**Bridge Factors Factual Report Attachment 32 – FIGG 3/15/18 Power Point Presentation**

# FIU - Sweetwater University City Bridge

## Temporary Construction Loading Condition

Additional Review of Pylon Diaphragm Region  
(Type II Deck End Diaphragm)

# Crack Notification – March 13, 2018

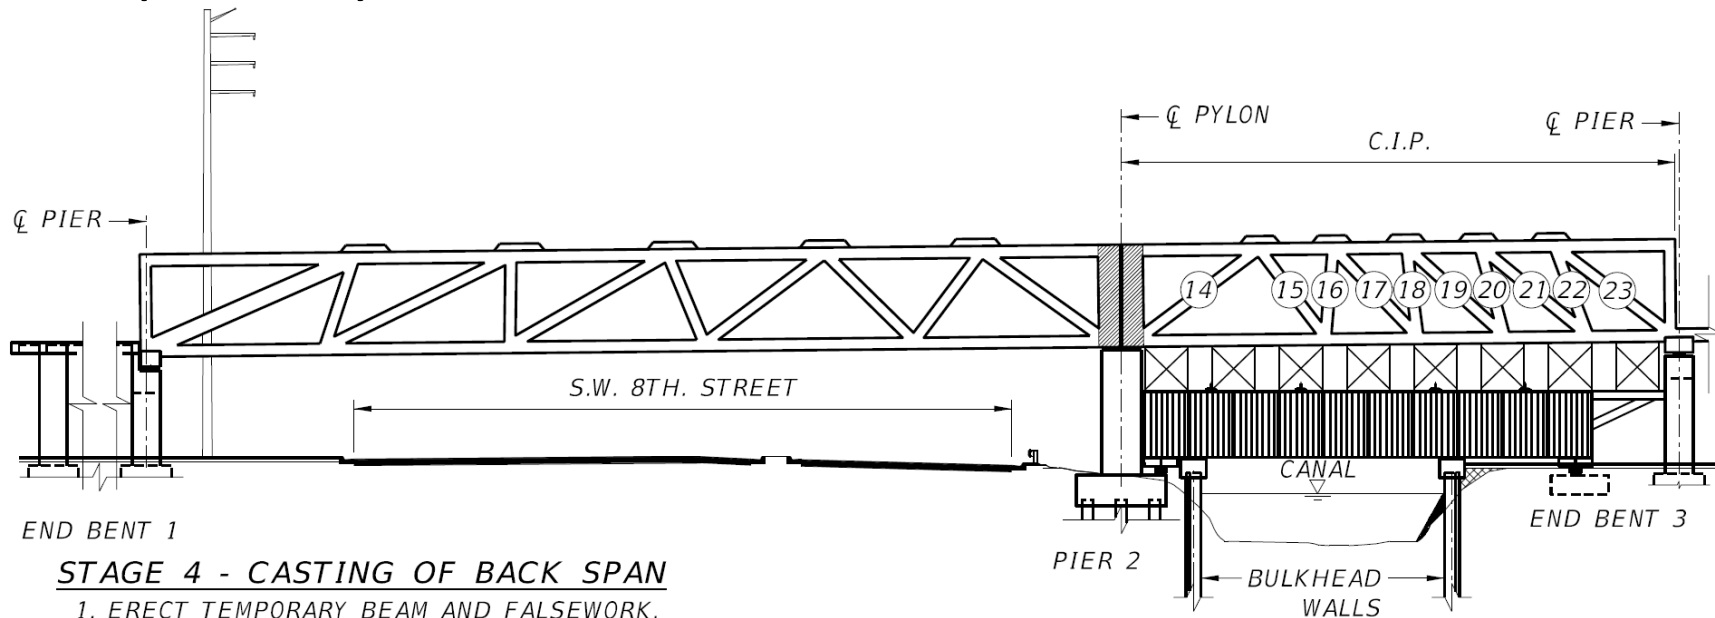
- FIGG was notified by MCM's email of 4:52 pm 3/12/2018 that some cracks and spalls had developed at the pylon diaphragm end of the span. Below are photographs of the West side.

- FIGG was notified by MCM's email of 4:52 pm 3/12/2018 that some cracks and spalls had developed at the pylon diaphragm end of the span. Below are Photographs of the East side

# Immediate Actions

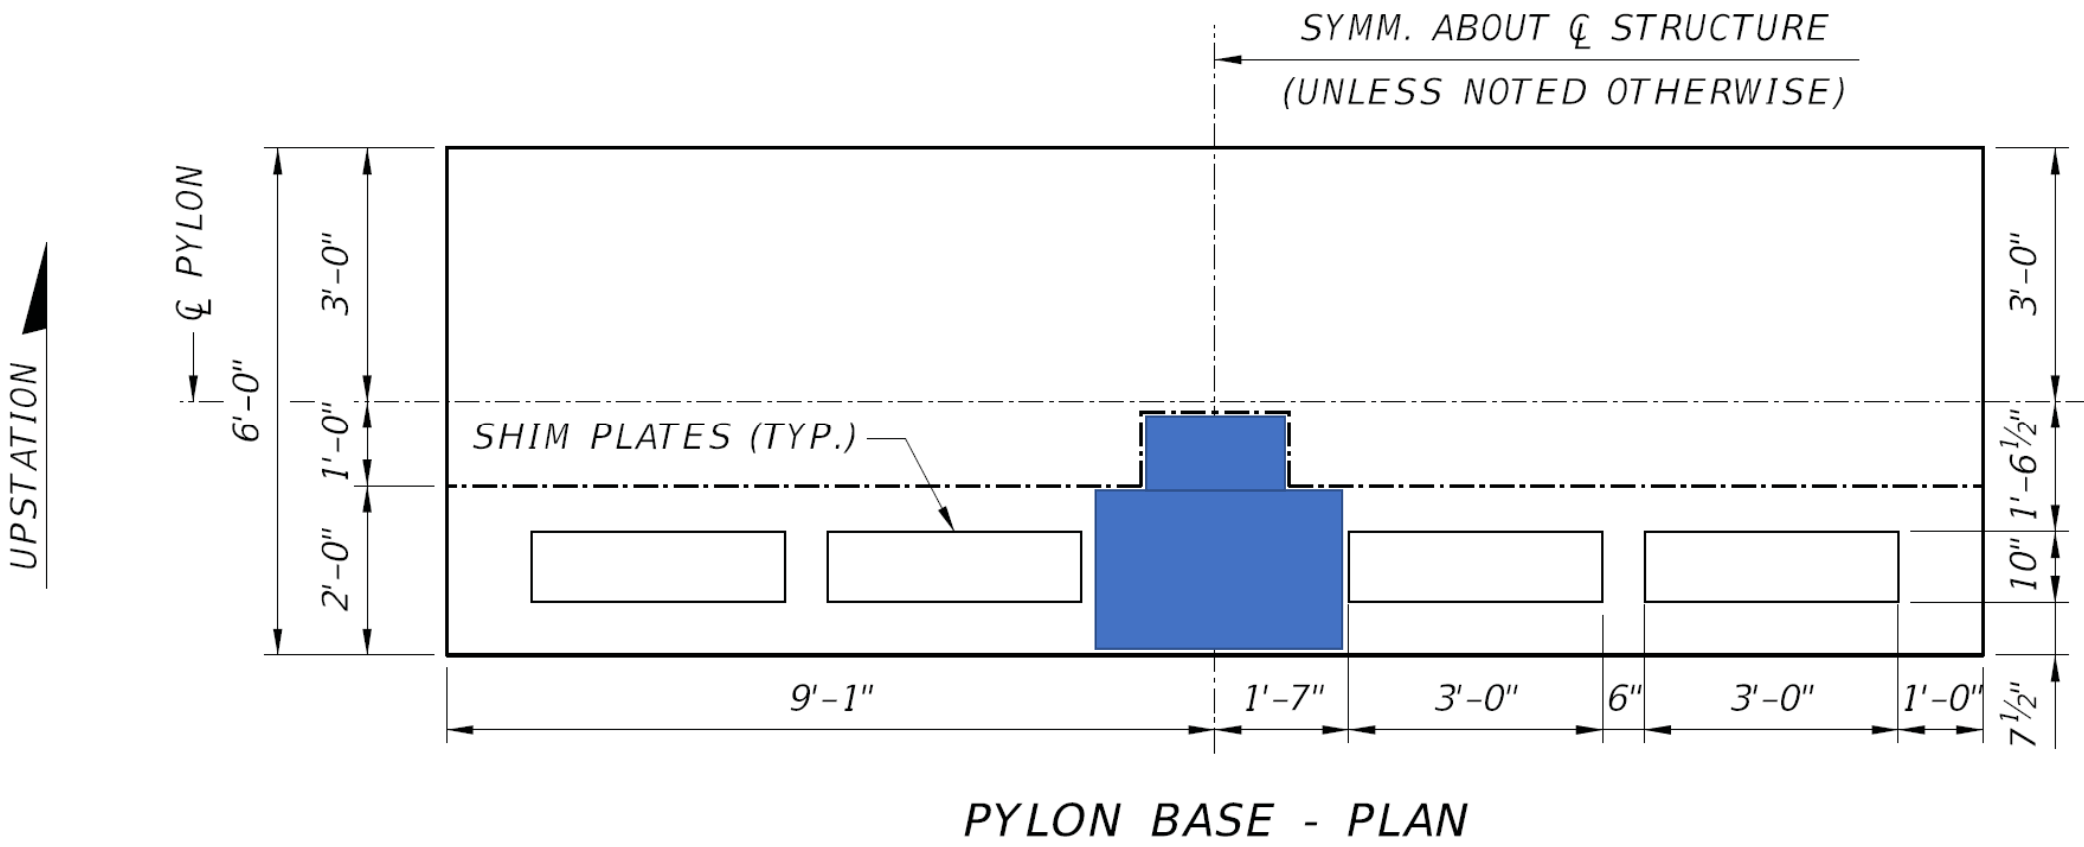
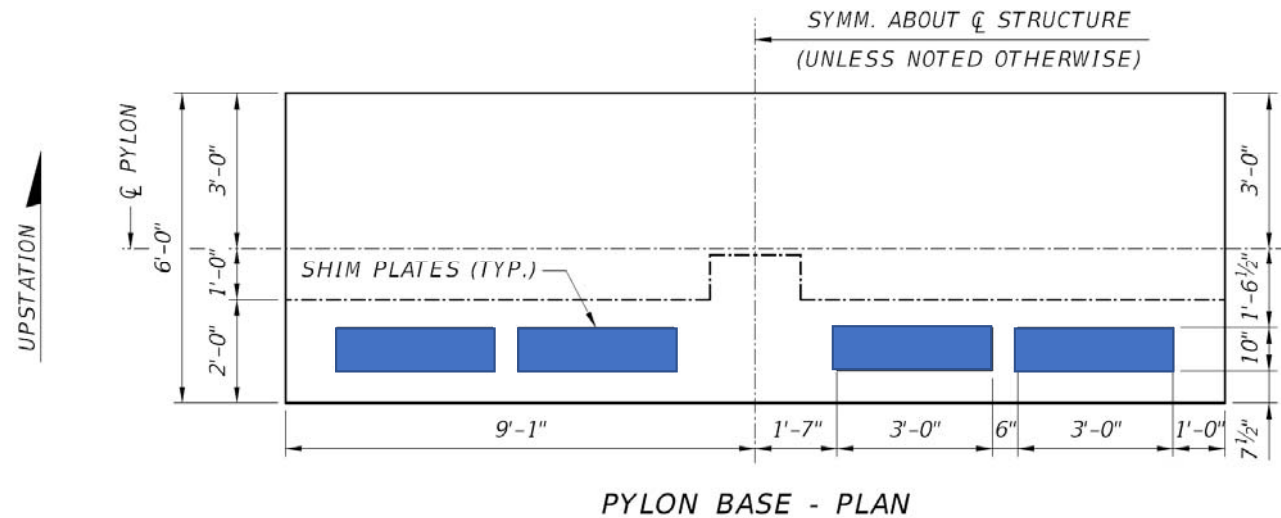
- Tuesday morning, upon seeing MCM's information, FIGG requested that, as a prudent action, MCM immediately install temporary shims directly below the nodal area of members 11/12 and the top of the Pylon/Pier, while further evaluations were on-going by FIGG.

The recommended temporary shimming region is shown below, in blue:

- Tuesday morning, after about an hour of review and evaluation, FIGG had conducted sufficient supplemental/independent computations to conclude that there is not any concern with safety of the span suspended over the road.
- MCM was so notified by Dwight Dempsey.
- The methods and results of this independent evaluation will be discussed in some detail further below.

# Strut and Tie Design Strength Check

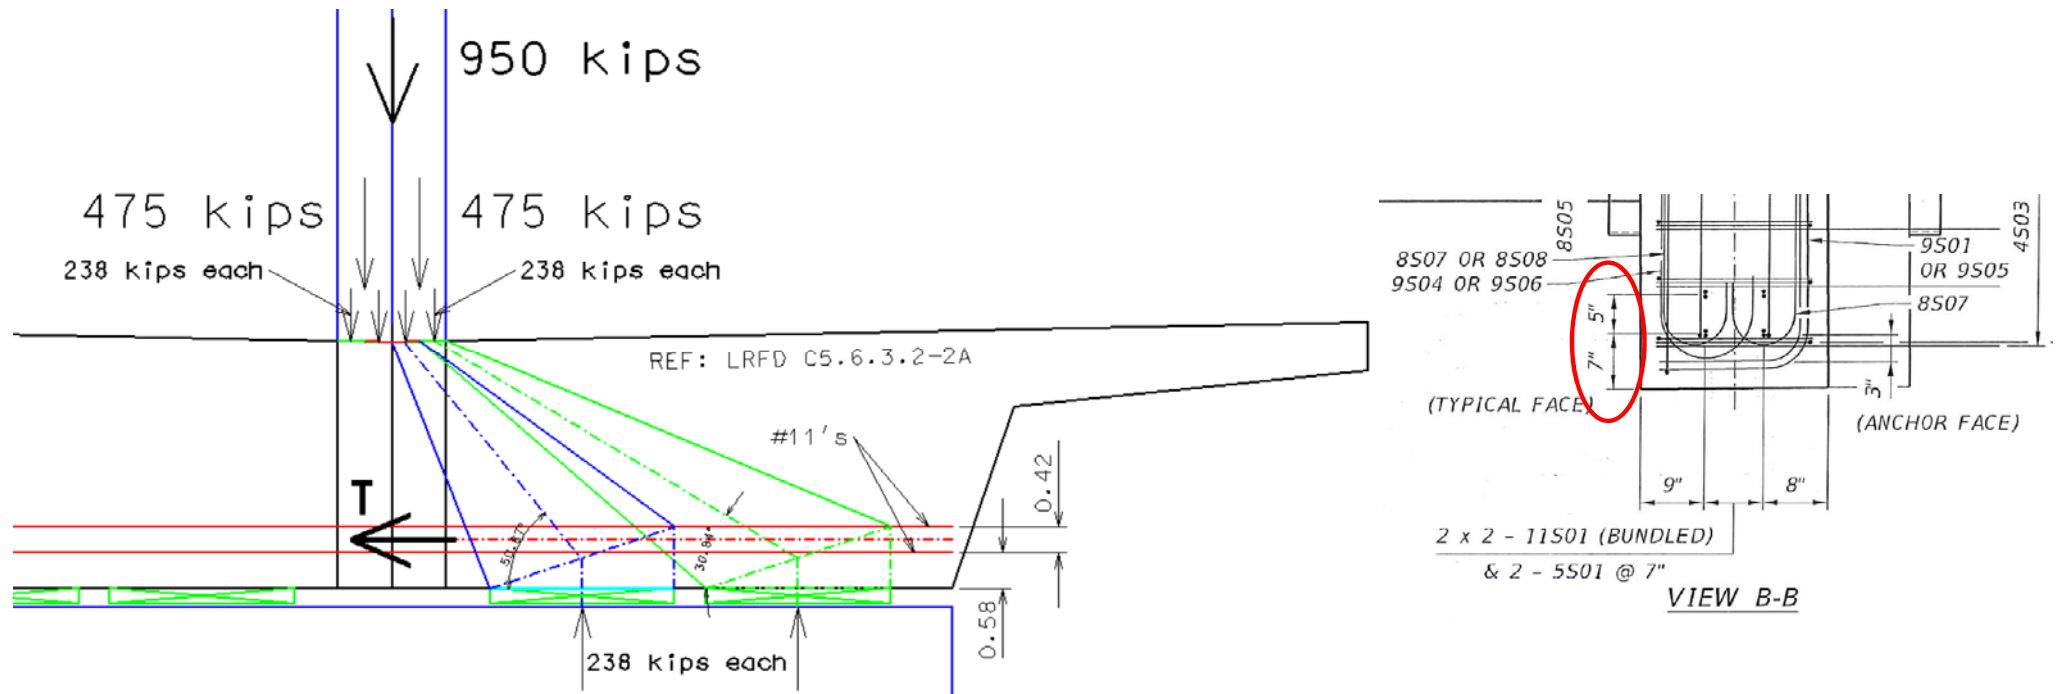
- Given the dimension of this region, the most appropriate design approach is the strut and tie method of LRFD 5.6.3

- $T1 = 238 \text{ kips} / (\tan (50.87 \text{ deg})) = 194 \text{ kips}$
- $T2 = 238 \text{ kips} / (\tan (30.84 \text{ deg})) = 399 \text{ kips}$
- Total Tension (T) = 593 kips (un-factored)

# Total Nodal Shear Stability

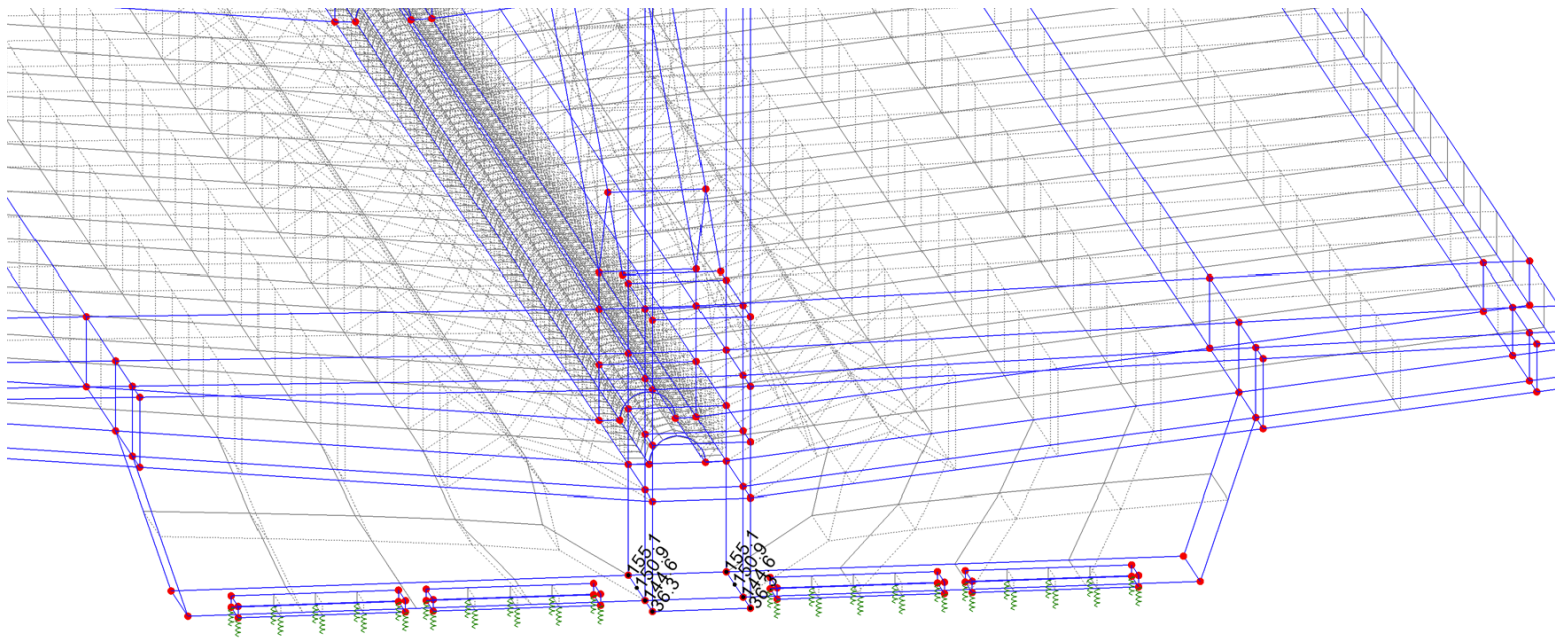
- The factored Demand Nodal Shear =  $(1.1)(1803 \text{ kips}) = 1983 \text{ kips}$
- This is less than either of the  $(\phi)(V_{ni})$  values, So ... Check = OK.
- Note, the upper limits for  $V_{ni}$  (LRFD 5.8.4.1-4 and 5.8.4.1-5) were checked and also found to be within limits.

# Diagonal Crack Pattern

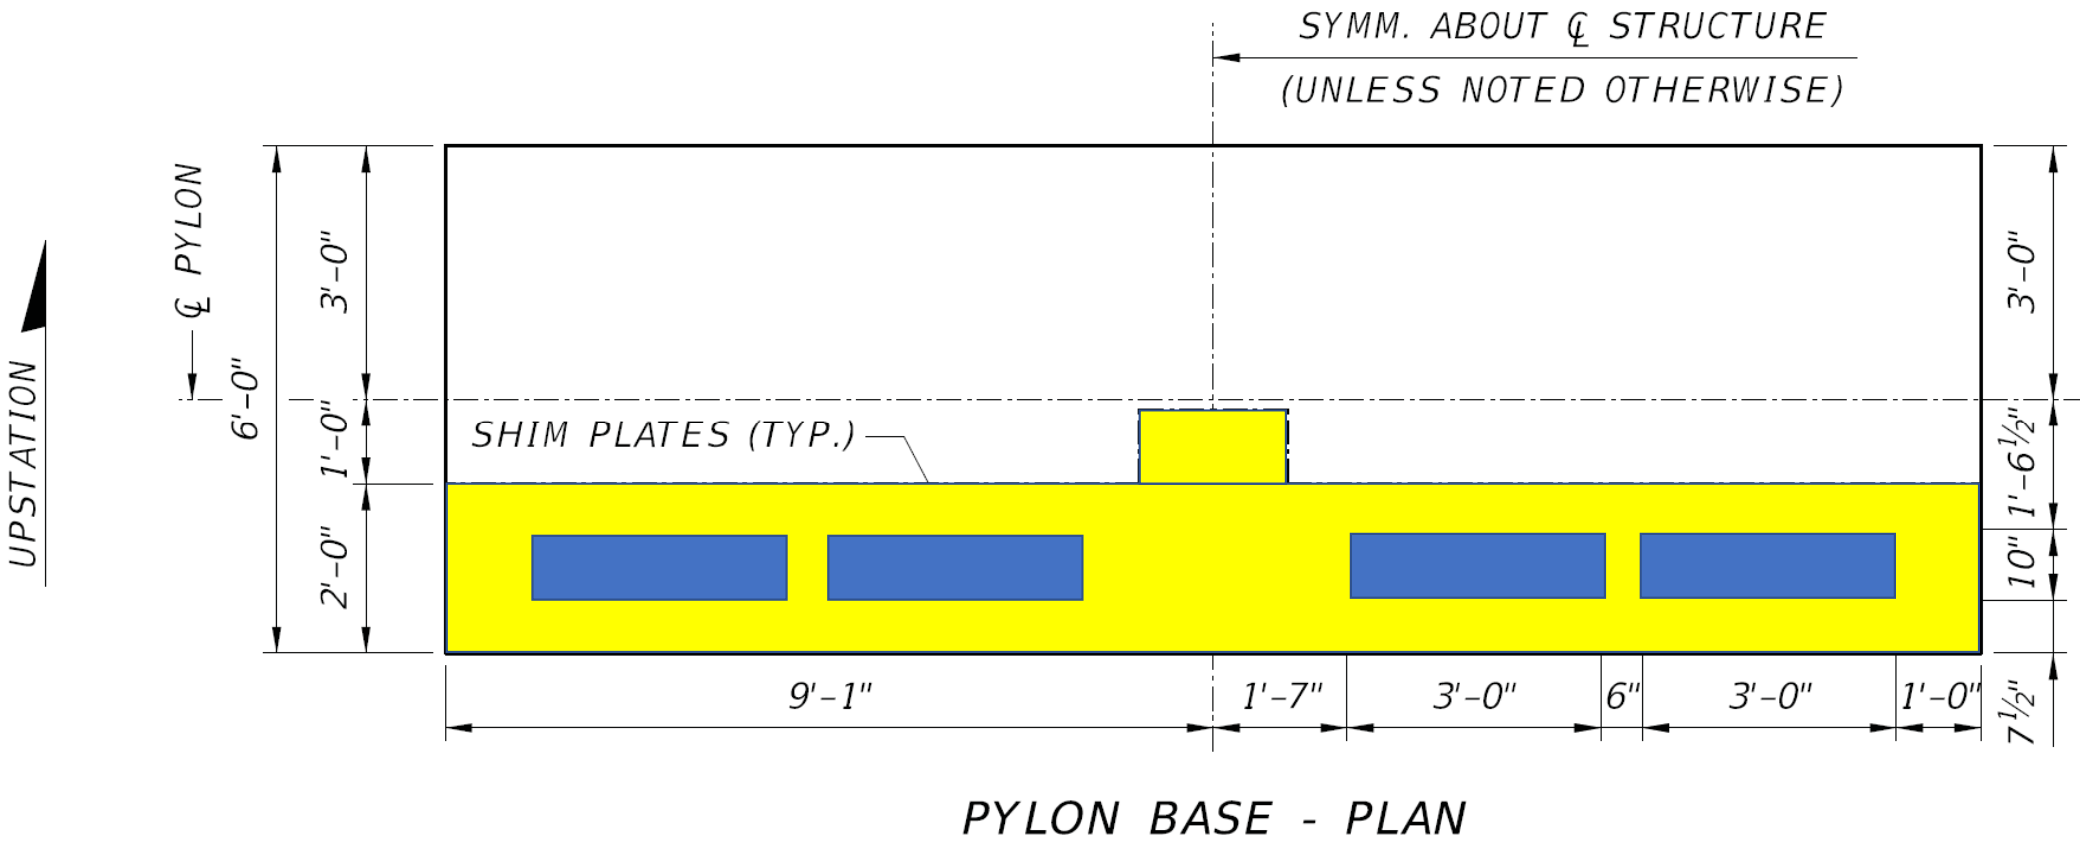
- Both the hand calculations and the 3D volume element analysis concur that some cracks of the nature photographed are possible
- Why the cracks did not develop in the casting area, is likely related to having a substantial portion of the load carried in the central area
- Having the smaller crack width on the permanently exposed face is preferable, when compared to the other (to be embedded) diaphragm face.

- The diagonal type cracks, in excess of FDOT criteria, should be sealed with approved methods and materials (Epoxy injection, etc.)
- The spalled areas have not been replicated by the engineering analyses. However ...
- The spalled areas are minor and it is recommended that they be prepared using normal procedures and poured back along with the up coming “pylon diaphragm” pour (different from and prior to the back span on falsework pours)
